Historic Landmarks Committee

Certificate of Approval for Alterations

HL 4-19

714 SE Washington Street

CRITERIA 17.65.060(B)(2)(b)

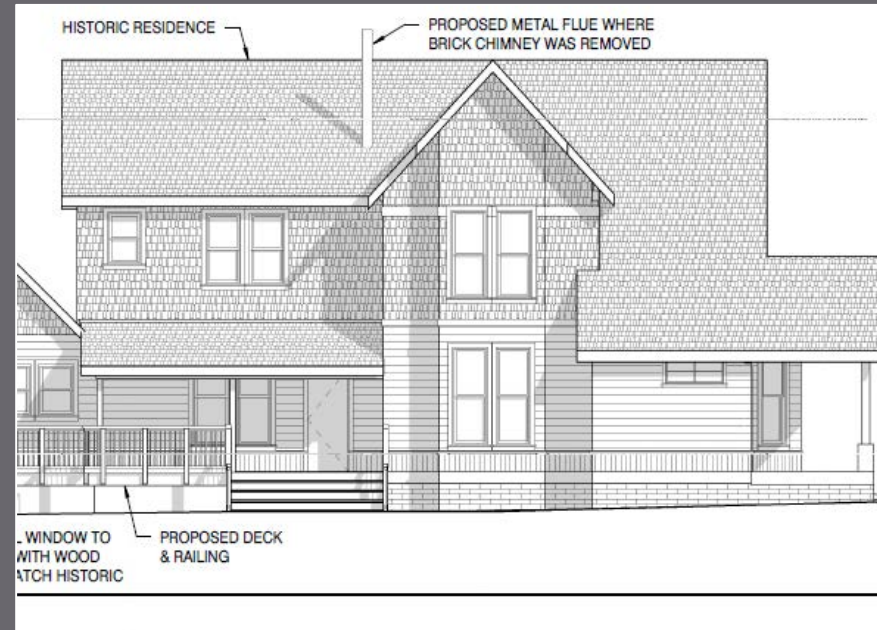
- The historic character of a property will be retained and preserved. The replacement of intact or repairable historic materials or alteration of features, spaces, and spatial relationships that characterize a property will be avoided.
- Main home and historic features being preserved
- Majority of proposed alterations to single story addition in rear
- New garage and ADU proposed to be detached in rear & designed to match historic home
- Suggested Condition: Require remaining brick chimney to be repaired or replaced around proposed metal flue

1. The existing brick chimney shall either be repaired or replaced by a similar brick chimney that will encase the proposed metal flue associated with the addition of a wood burning stove in the historic residence. The repaired or new brick chimney should match the existing chimney in height, depth and any assorted brick design.

CRITERIA 17.65.060(B)(2)(c)

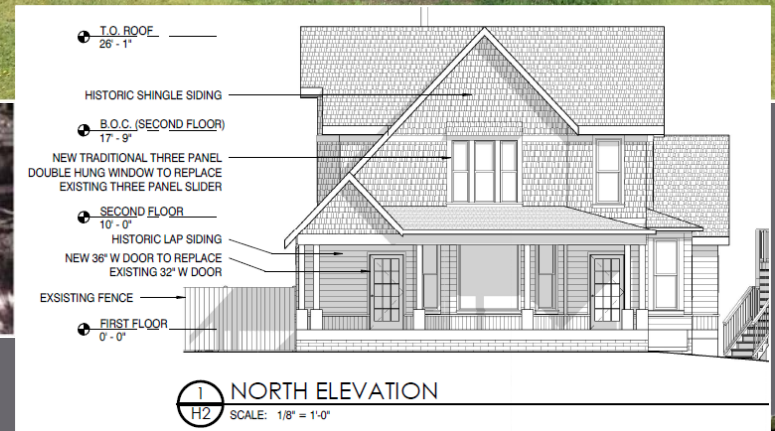
- Each property will be recognized as a physical record of its time, place, and use. Work needed to stabilize, consolidate, and conserve existing historic materials and features will be physically and visually compatible, identifiable upon close inspection, and properly documented for future research.
- Replacement and expansion of deck on east façade – removal of existing incompatible features
- Replacement of existing vinyl windows with wood windows
- Suggested Condition: All windows and doors replaced and new be wood windows and doors

2. That all windows and doors proposed to be replaced be replaced with wood windows and doors to match the existing structure's materials. The new windows and doors on the garage and ADU shall also be of wood materials. The replacement and new windows and doors shall include the wood trim and window sill design that exists on the remainder of the windows and doors on the existing structure.

CRITERIA 17.65.060(B)(2)(f)

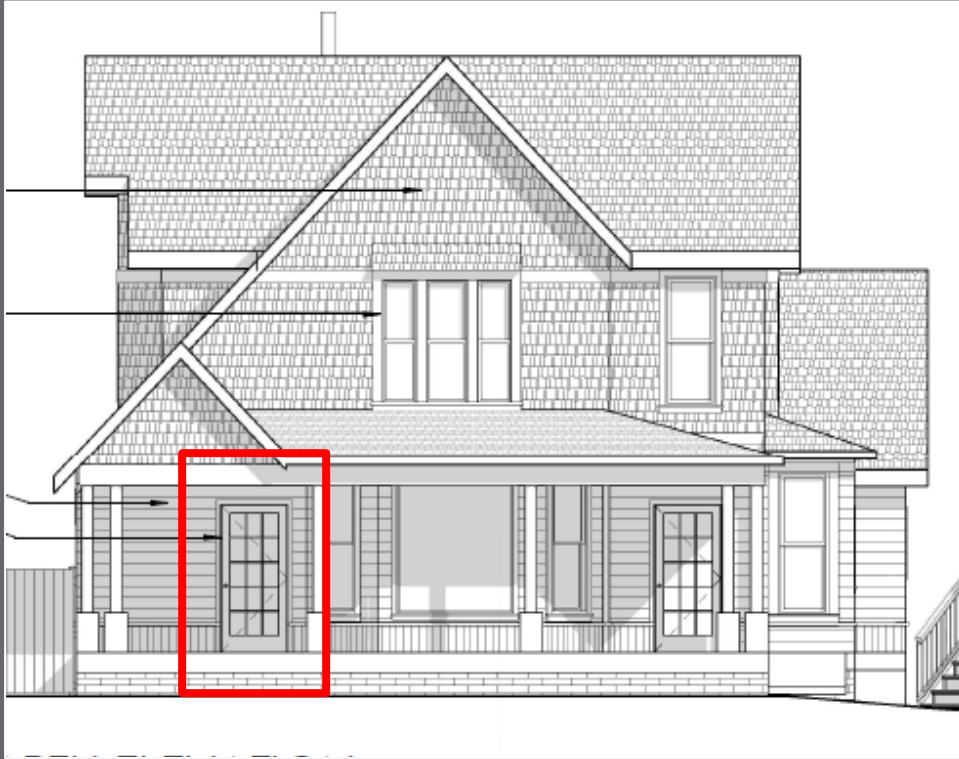
- The existing condition of historic features will be evaluated to determine the appropriate level of intervention needed. Where the severity of deterioration requires repair or limited replacement of a distinctive feature, the new material will match the old in composition, design, color, and texture.
- Existing deck and railing proposed to be replaced and expanded
- Front door proposed to be replaced and expanded
- Suggested Condition: Require new front door to match other existing front door with glazing and grid system

3. That the new front door be consistent in style with the existing door being replaced. The new door shall include the glazing pattern and grid system within the glazed portion of the door, and shall match the other existing front door on the street-facing façade of the structure in design, materials, and color.
